STATE OF DELAWARE
EXECUTIVE DEPARTMENT
OFFICE OF
STATE PLANNING COORDINATION

RE: PLUS review – PLUS 2005-02-05; Fed Ex Ground Small Package Facility

According to the information received, you are seeking site plan approval for a 78,661 square foot package handling facility on 15.57 acres.

Fed Ex Facility - Seaford

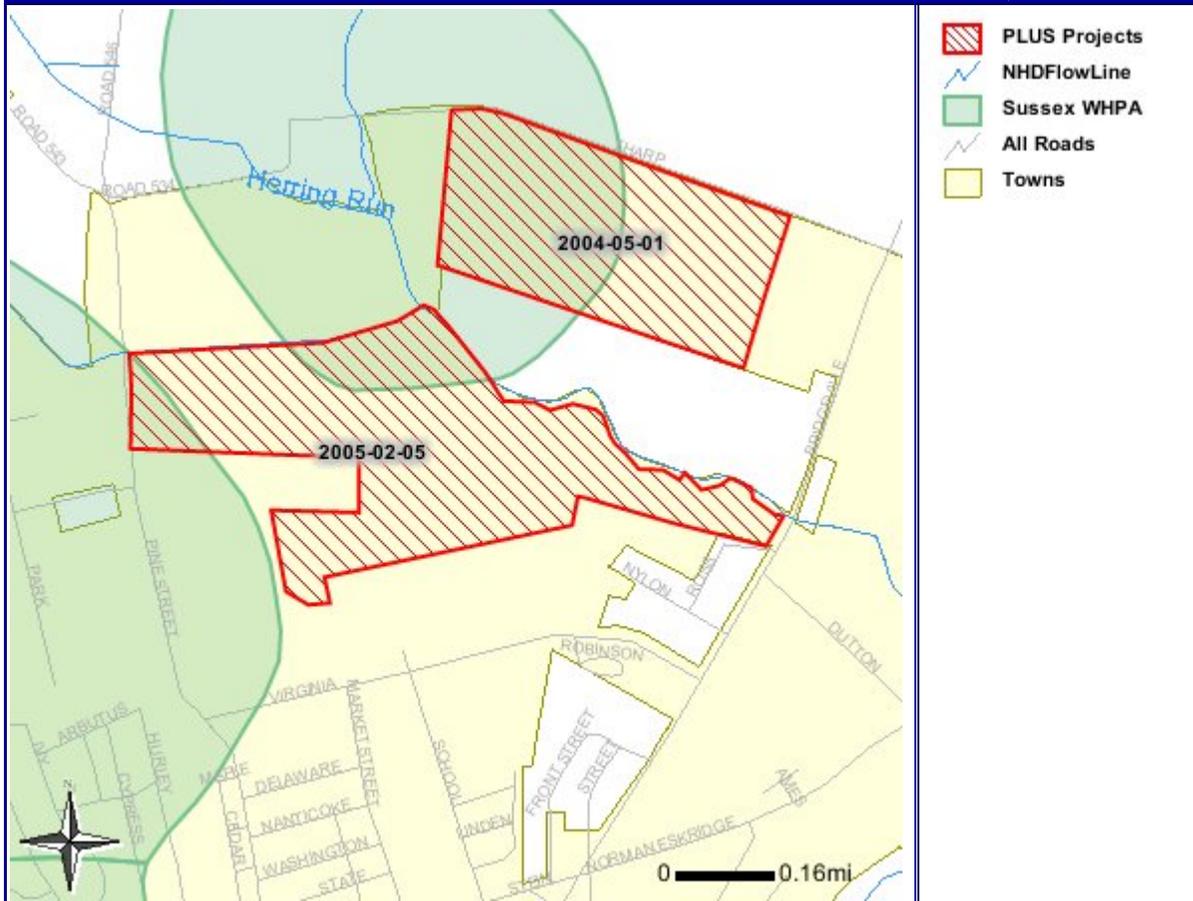
A portion of the site falls within a wellhead protection area (see map). Wellhead protection areas are surface and subsurface areas surrounding a public water supply well where the quantity and quality of groundwater moving toward such wells may be adversely affected by land use activities.

- 1) Preserve WRPA's as open space and parks by acquisition or conservation easement.
- 2) Limit impervious cover of new development to 20 % by right within WRPA's.
- 3) Allow impervious cover of new development to exceed 20% within WRPA's (but no more than 50% impervious) provided the applicant develops recharge facilities that directly infiltrate rooftop runoff.
- 4) Allow impervious cover of new development to exceed 20% within WRPA's (but no more than 50% impervious) provided the applicant develops recharge facilities that infiltrate stormwater runoff from forested and/or grassed surfaces with pretreatment.
